UNITED STATES PATENT AND TRADEMARK OFFICE

APPLICATION NO.	FILING DATE	FIRST NAMED INVENTOR	ATTORNEY DOCKET NO.	CONFIRMATION NO.
10/629,873	07/30/2003	Shingo Johgan	4034-39	7357
23117	7590	11/15/2005	EXAMINER	
NIXON & VANDERHYE, PC 901 NORTH GLEBE ROAD, 11TH FLOOR ARLINGTON, VA 22203			WANG, GEORGE Y	
			ART UNIT	PAPER NUMBER
			2871

DETAILED ACTION

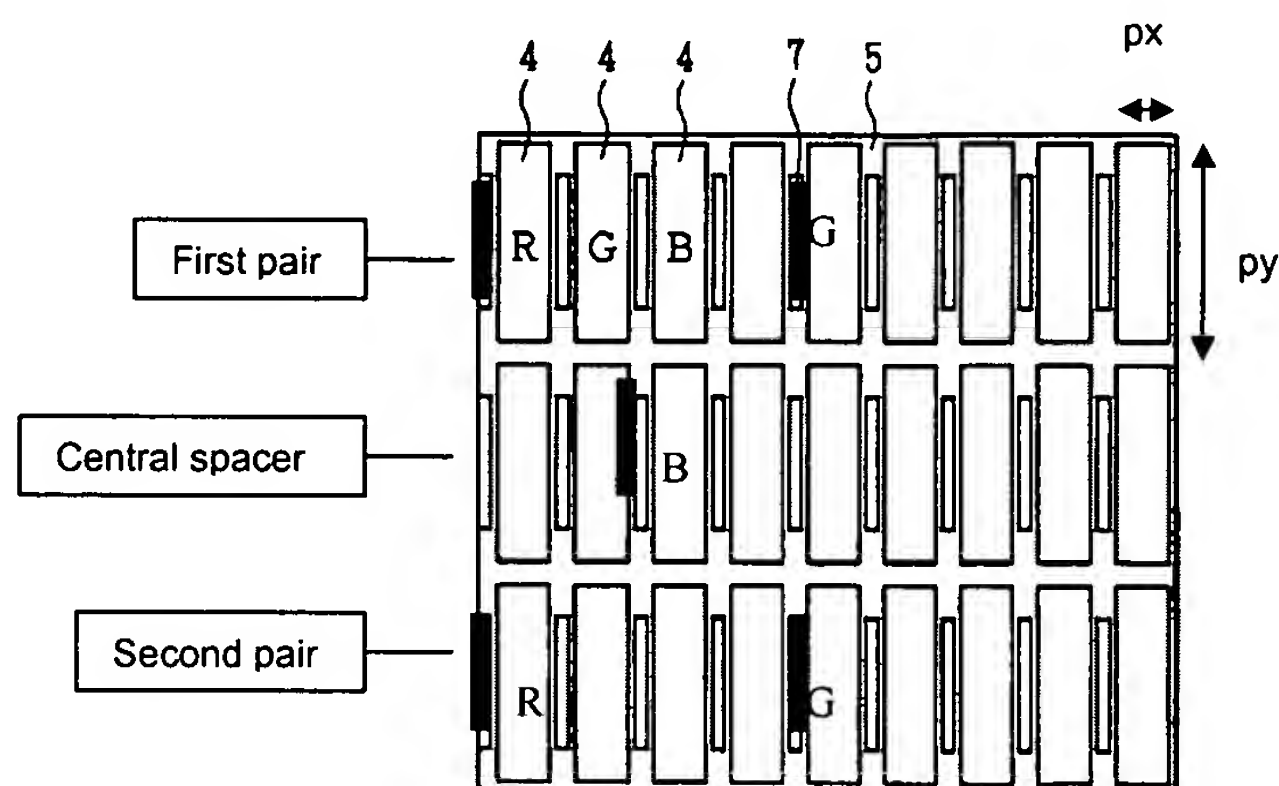
5. As per claims 5-6, Izumi discloses the color filter substrate as recited above, where the color filters are arranged at a predetermined pitch, p_x , in a row direction and at another predetermined pitch, p_y , in a column direction, respectively, and where the spacers include a set of five spacers, the first pair being separated from each other by a distance of $m * p_x$ (where m is an integer equal to or greater than 2 by is not a multiple of 3) in a row direction, the second pair being separated from the spacers of the first pair by a distance of $n * p_y$ (where n is a positive integer and a multiple of 2) in the column direction, and the central spacer being separated from the spacers of the first pair by a distance of $m * p_x/2$ in the row direction and by a distance of $n * p_y/2$ in the column direction, respectively (see clarifying references included by Examiner in fig. 5 below), such that the first pair of spacers and the central spacer consist of a first spacer, a second spacer, and a third spacer associated with the first, second, and third groups of color, respectively, the second pair of spacers and the central spacer consist of

another first spacer, another second spacer, and another third spacer associated with the first, second and third groups of color filters, respectively (see clarifying references included by Examiner in fig. 5 below).
